Public Comment Received for:

Item 5: 1460 La Cima Rd

(PLN2019-00279)

March 11, 2022

1460 La Cima Road – Comments to Sheet A 1.0

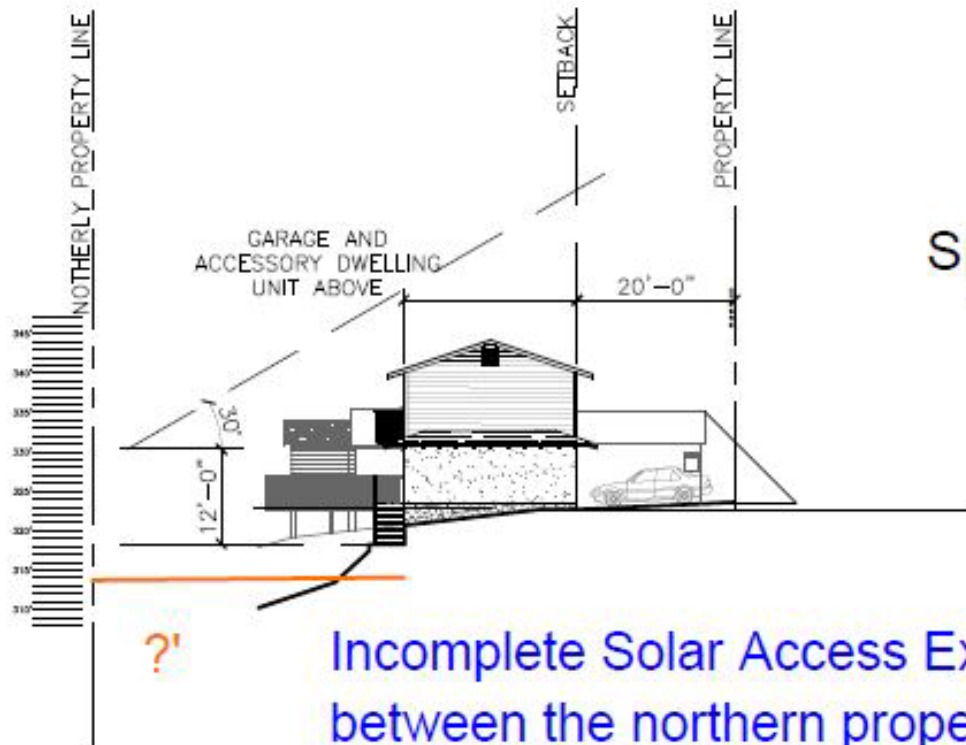
Sheet A-1.0: The proposed structure has increased in width and size overall since this project was reviewed in October, but gross square footage shown on the plans is 1,334 s.f., which is less than the previous design gross area of 1,423 s.f. Also both the gross and net square footages indicate the second story ADU is greater in size than the first story garage. It is unknown whether this is an error. Thus it appears the square footage calculations and floor area ratio (the "FAR") needs to be confirmed.

Garage width increased by 2'8", but gross s.f. is less than previous design?
 Confirm areas and FAR

1460 La Cima Road – Comments to Sheet A 1.1

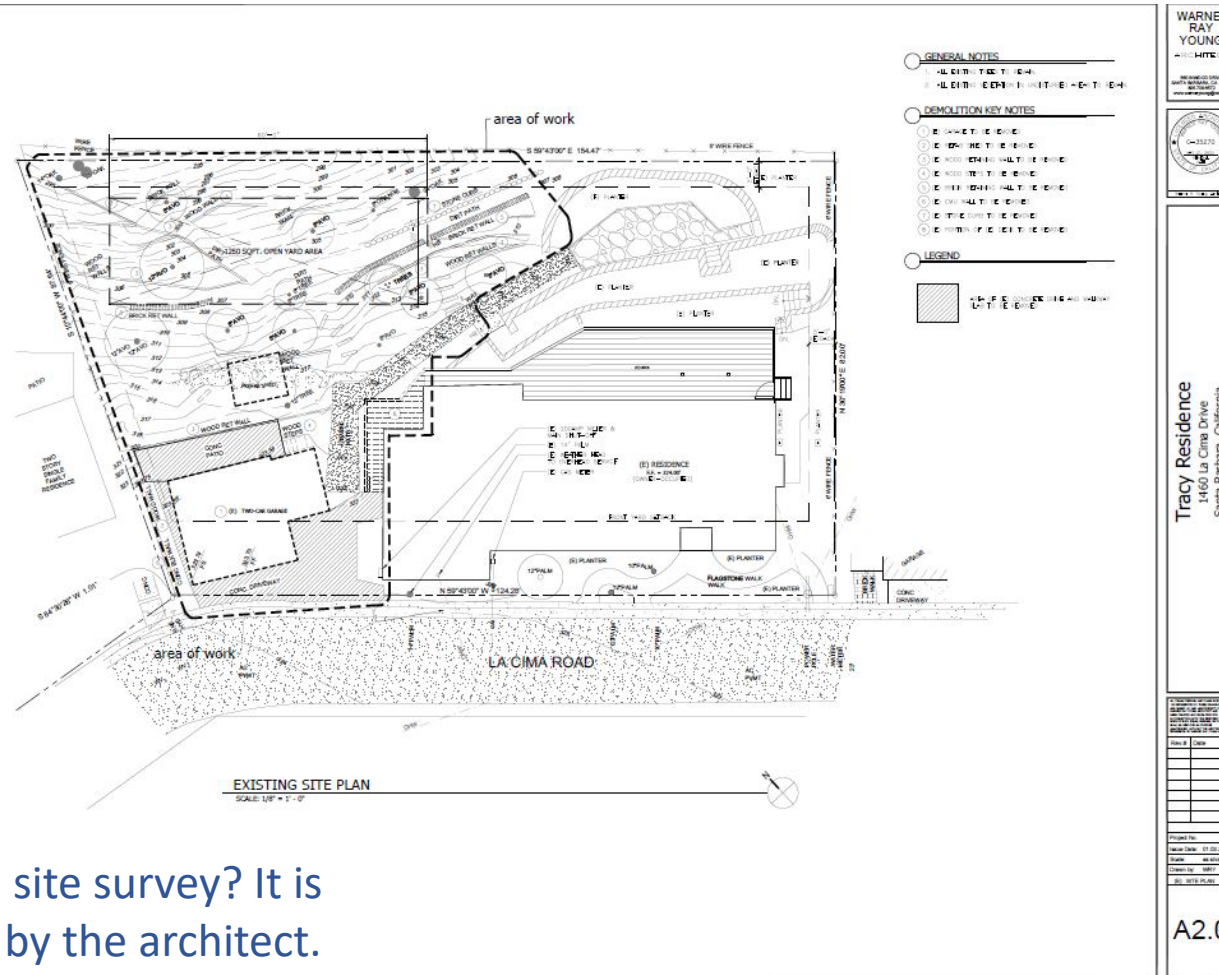
Sheet A-1.1: The Solar Access information provided is missing the dimension between the Northern property line and the proposed development. Also, the slope down to the northern property line is not shown. The topographic elevation of the natural grade is required to determine the Base Elevation Point and ensure the Project meets the Solar Access Height Limitation required by SBMC 30.140.170.

? Incomplete Solar Access Exhibit. Where is the dimension between the northern property line and the proposed structure? Also the slope down to the property line is not shown.

1460 La Cima Road – Comments to Sheet A 2.0

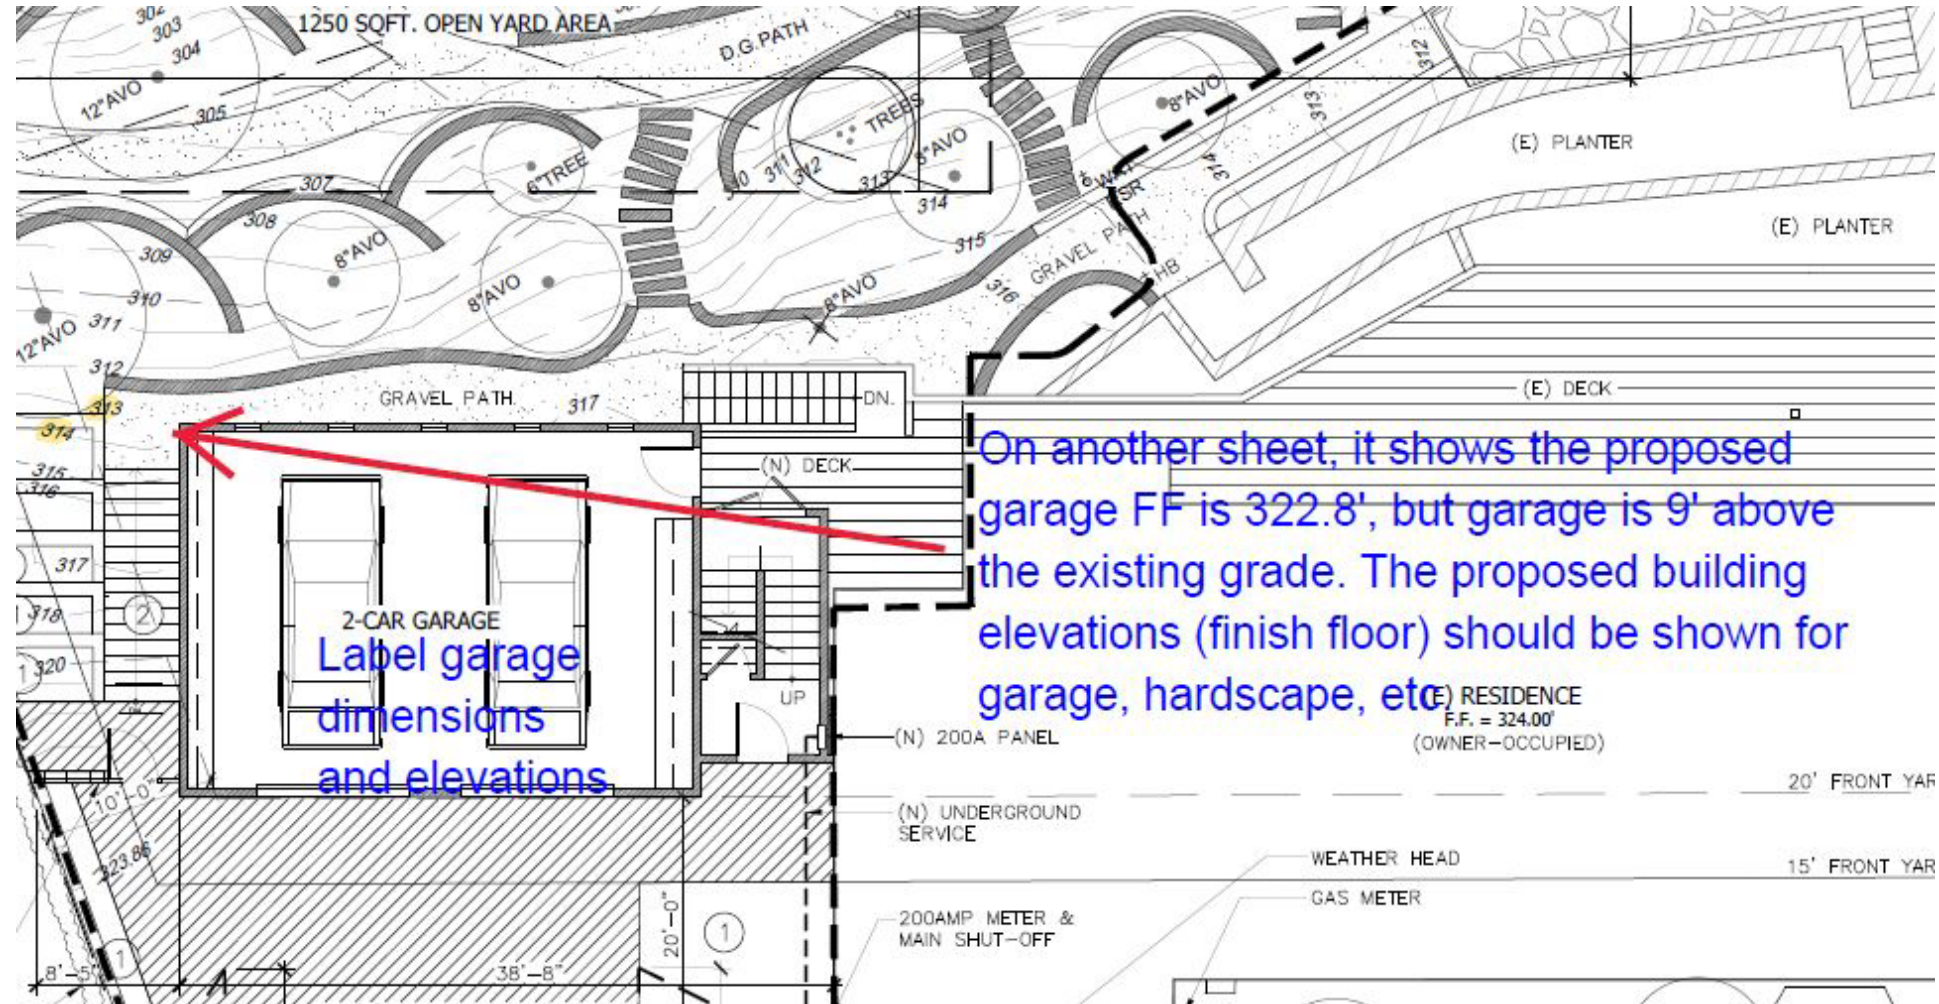
Sheet A-2.0: It unclear who prepared the topographic site survey, nor is it stamped by a licensed surveyor. If the topographic survey was prepared by a licensed surveyor, was SBMC 30.150.030 used to determine the average slope of the property, listed as 33% in the property data section on Sheet 1.0?

Who prepared the site survey? It is stamped & signed by the architect.

1460 La Cima Road – Comments to Sheet A 2.1

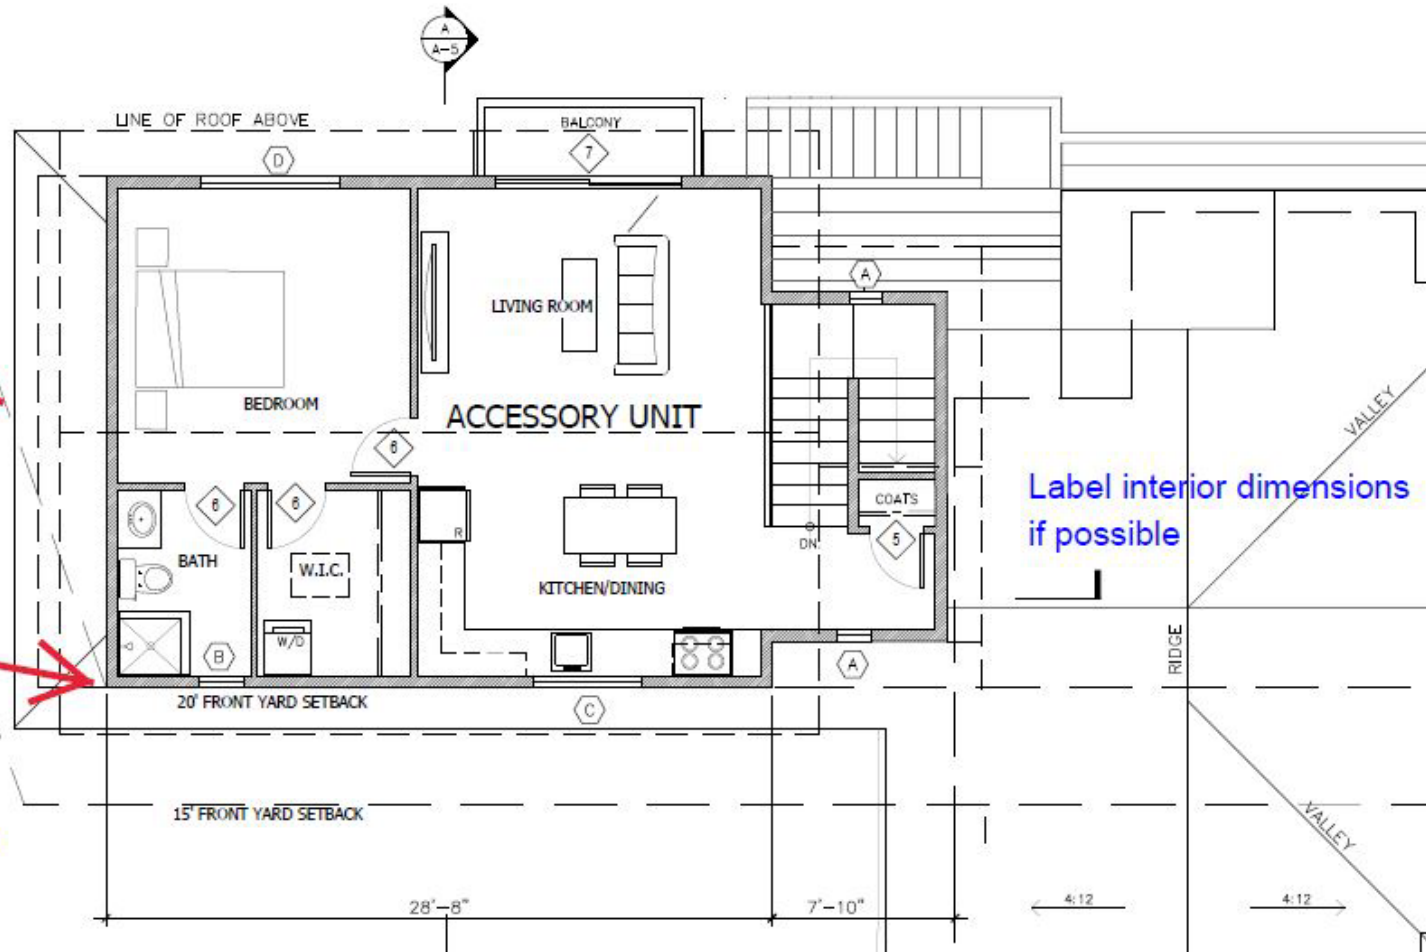
Sheet A-2.1: It would be helpful to have the interior floor plan dimensions, as well as the grade elevations of all the proposed improvements, including the proposed finished floor elevation of the garage, the driveway and other hardscaped areas. The footprint of the garage appears to be at the same location as the previous site plan, but the overall dimensions appear to have changed since the project was previously reviewed by SFDB. Thus it appears the structure's building footprint location should be confirmed. Finally, the Sheet number is cut off at the bottom.

On another sheet, it shows the proposed garage FF is 322.8', but garage is 9' above the existing grade. The proposed building elevations (finish floor) should be shown for garage, hardscape, etc.

Label garage dimensions and elevations

1460 La Cima Road – Comments to Sheet A 3.0

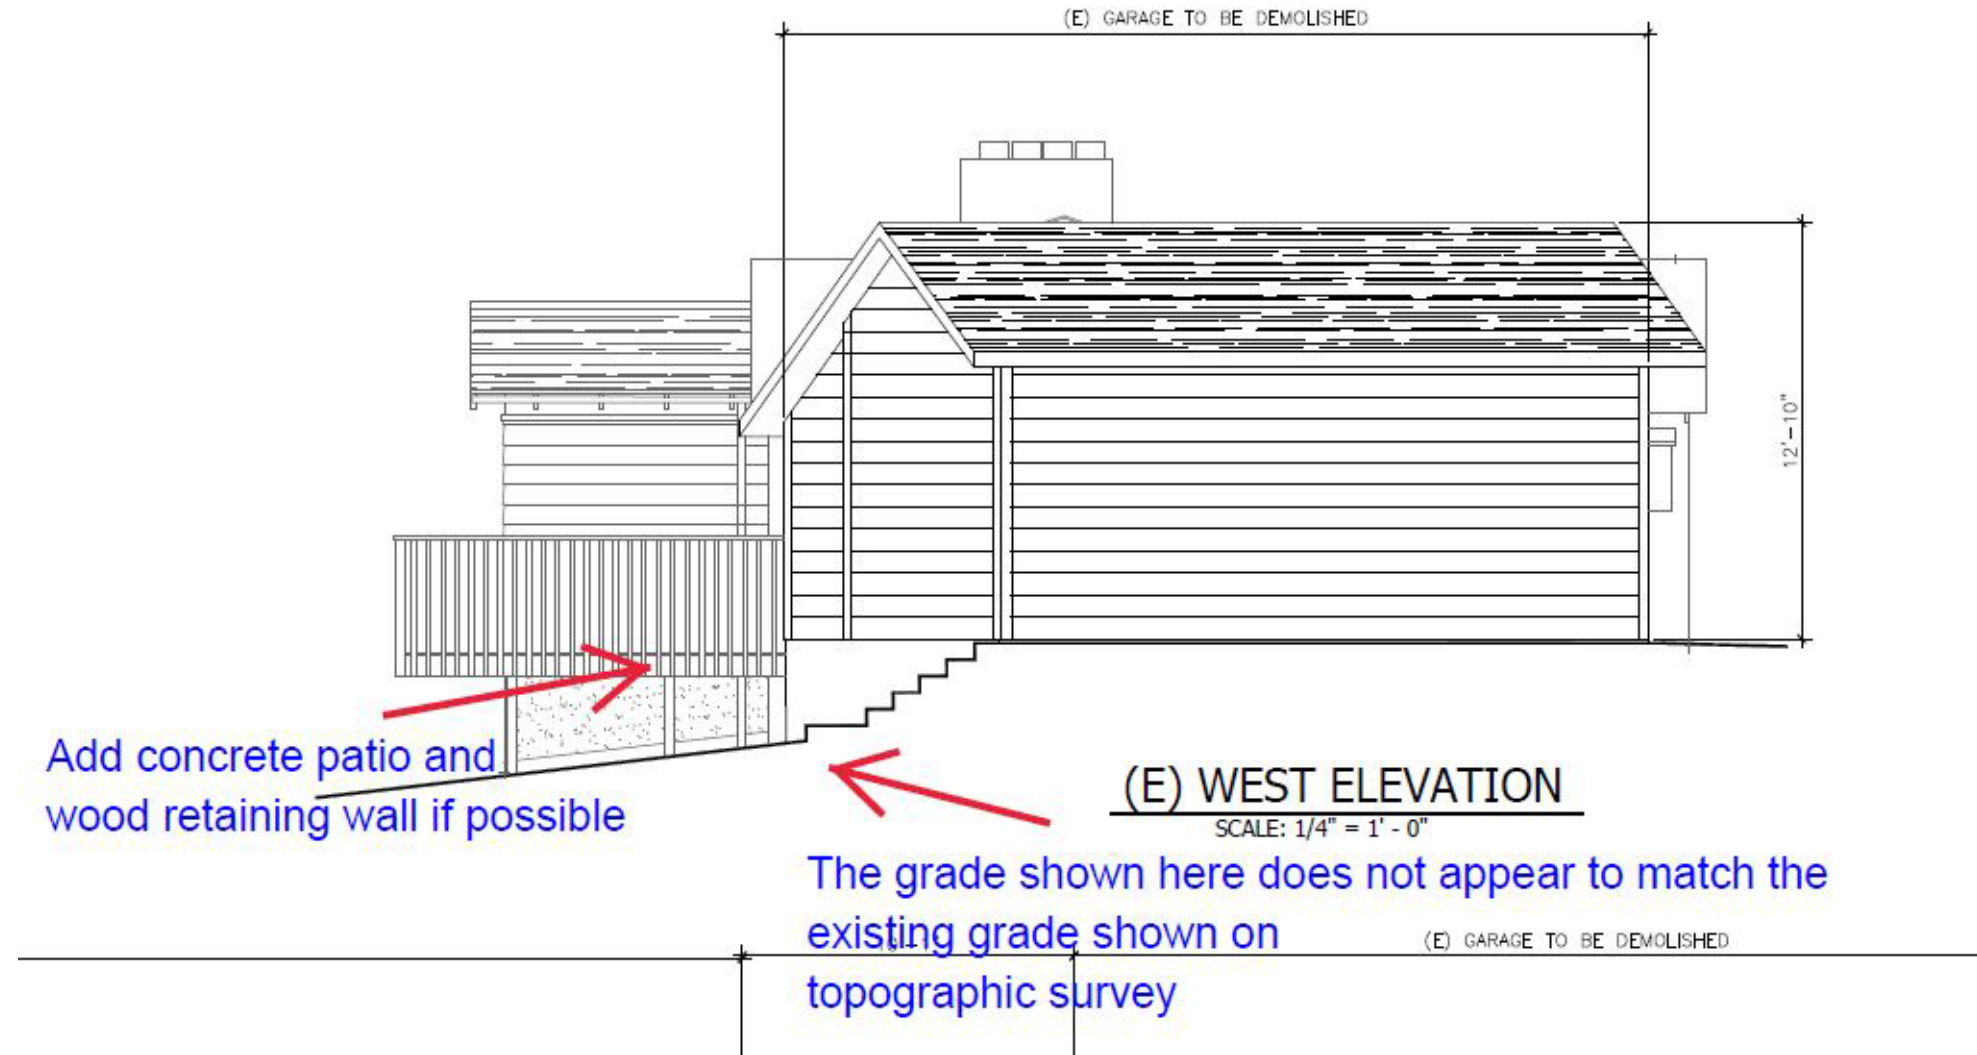
Sheet A-3.1: It would be helpful to see the dimensions of the proposed floor plans. It would also be helpful if the solid lines and dotted lines within the interior setback were labeled, to confirm what each represents, and confirm if any encroachments exist.

Label each dotted line

The proposed building is located right at the corner of the two setback lines. How far do these eaves and roof details encroach?

Label interior dimensions if possible

1460 La Cima Road – Comments to Sheet A 4.0

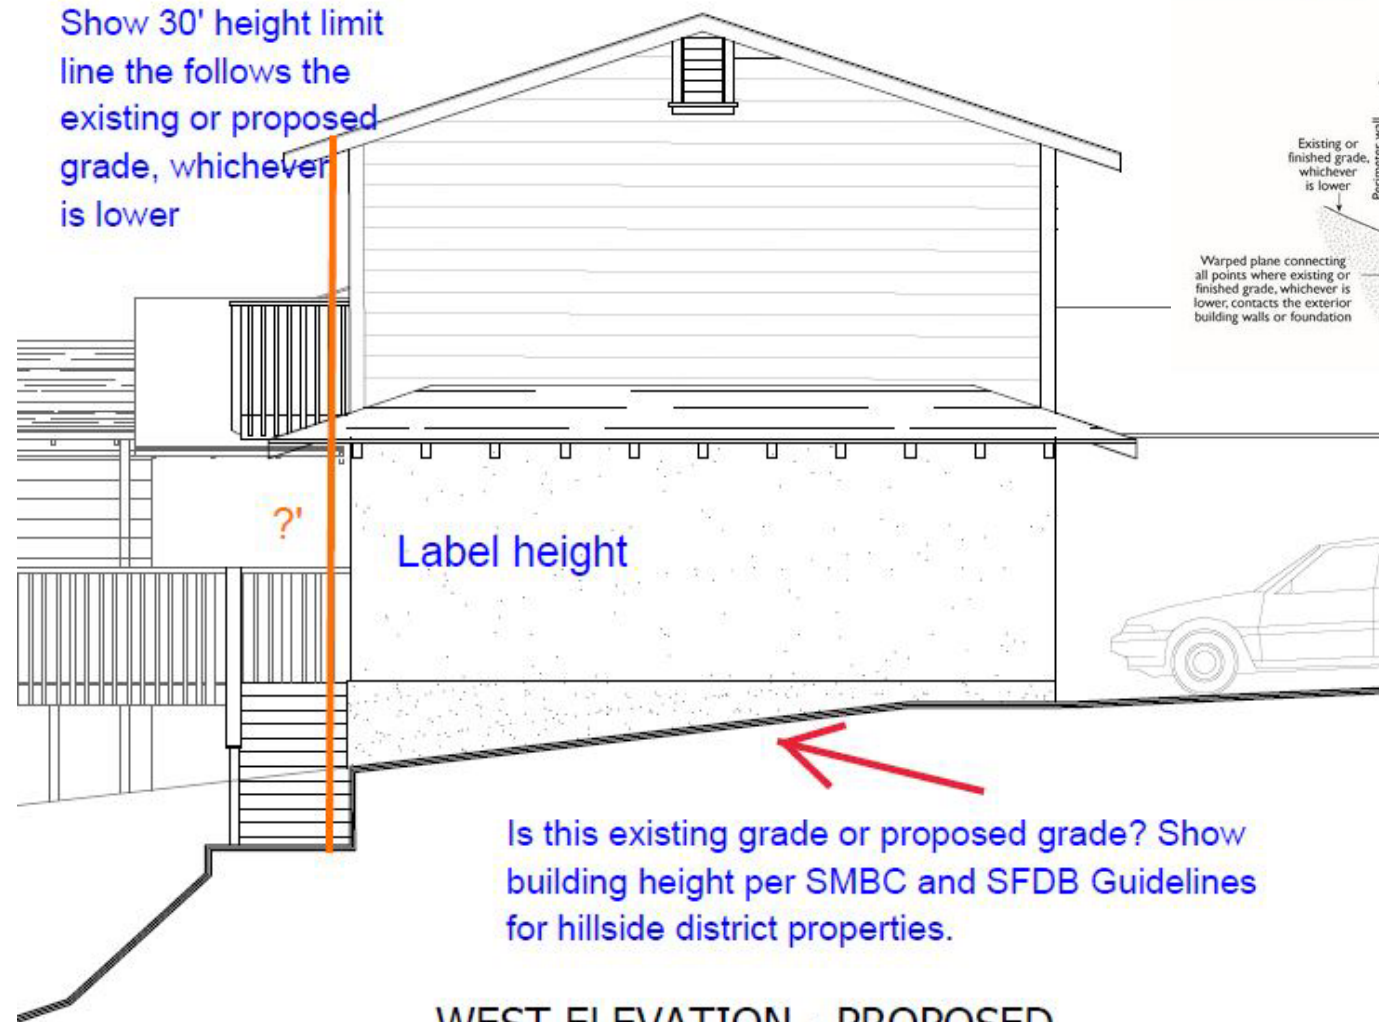
Sheet A-4.0: The topography shown on the West Elevation does not appear to be shown accurately, as the area South of the existing garage is quite steep. Also, the existing concrete patio and wood retaining wall South of the garage are not shown.

1460 La Cima Road – Comments to Sheet A 4.2

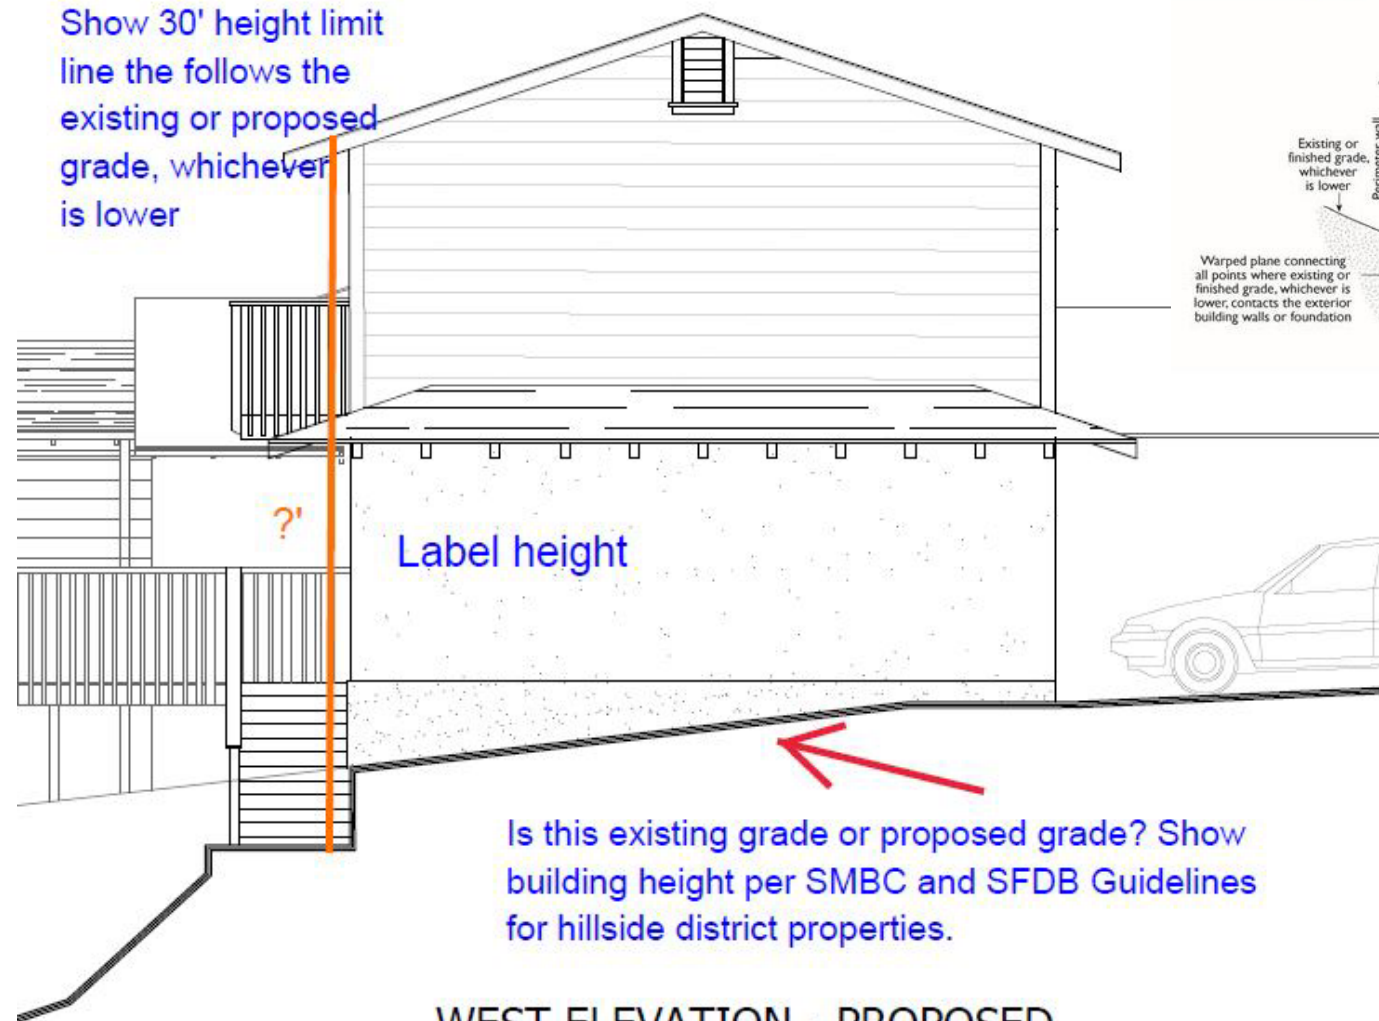
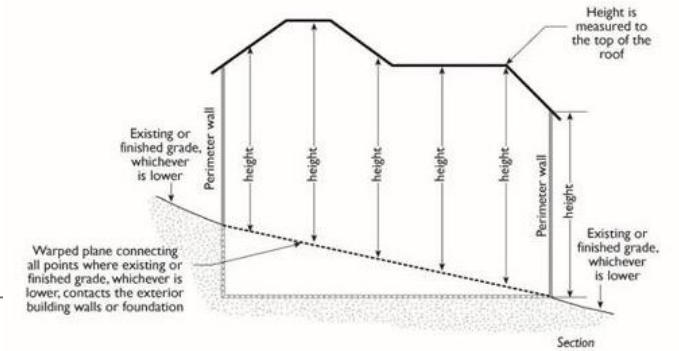
Sheet A-4.2: SBMC 30.15.090.A and Guideline #28 *Height and Proportions* in **EXHIBIT D** require building height to be measured from the existing grade or proposed grade, whichever is lower. Therefore, the topographic elevations of the existing grade and the proposed grade should be added to the West Elevation and sections, as well as the 30' height limit line to confirm the proposed structure does not exceed 30' in height, the maximum allowable height in the RS-6 zone.

Show 30' height limit line the follows the existing or proposed grade, whichever is lower

Label height

Is this existing grade or proposed grade? Show building height per SMBC and SFDB Guidelines for hillside district properties.
